Rezoning Application: PD 26-0217 (Revised)

**Hillsborough
County Florida**

Development Services Department

AGENCY REVIEW COMMENT SHEET

8.0 PROPOSED SITE PLAN (FULL)

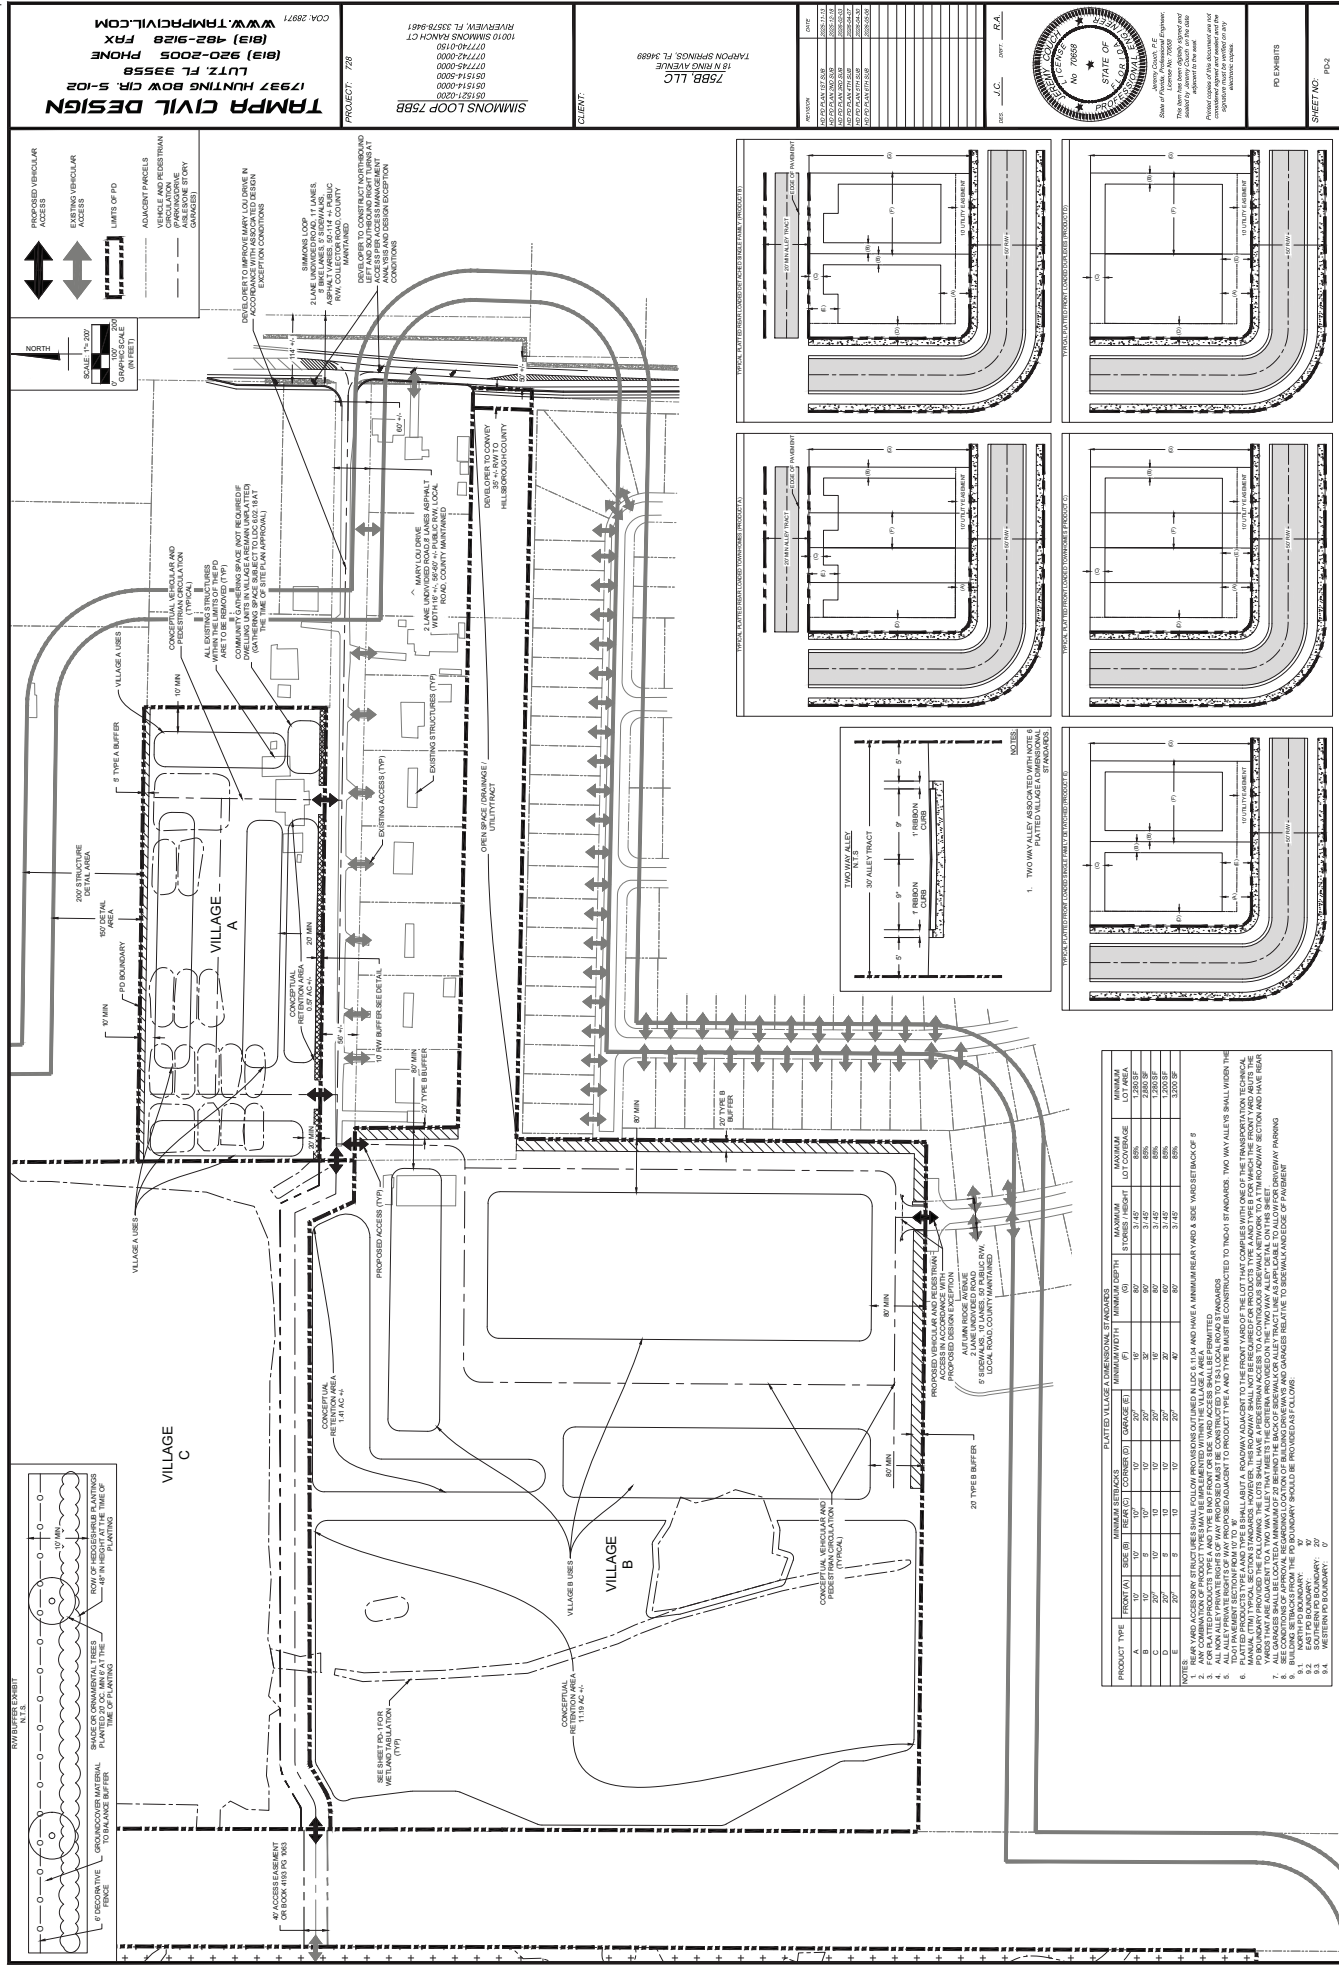
1. The developer shall revise both PD site plan sheets to show Bullfrog Creek and show/label the area of crossing as "~~Proposed Potential~~ Bridge/Culvert – See Conditions of Approval".

2. On PD site plan sheet PD-1:
 - a. ~~Within the "Allowable Uses by Village", Village A use list, delete the reference to "Cottages". Staff notes that no development standards for such use type are proposed delete the phrase "Platted or Unplatted:" and add the phrase ", All Platted or Unplatted" at the end.~~

- b. Revise Variation number 4 to state "Variation to LDC 6.06.06 to allow a 5' Type A buffer along the northern boundary line of Village A in lieu of the required 20' Type B buffer in the event Village A is platted or unplatted."

3. On PD site plan sheet PD-2:
 - a. Revise the inset titled "Two-Way Alley" to instead state "Two-way Alleyway for Units Not Fronting a Street or Driveway" and replace note 1 with a note which instead reads "See Conditions of Approval."

- b. Revise Note 1 within the "Platted A Dimensional Standards" table, to add "No accessory structures shall be permitted within a front or side yard which provides vehicular access." to the end of the note.

- c. Revise Note 6 within the "Platted A Dimensional Standards" table, to replace the words to correct the note to reflect the inset title change per condition 2.a., above.
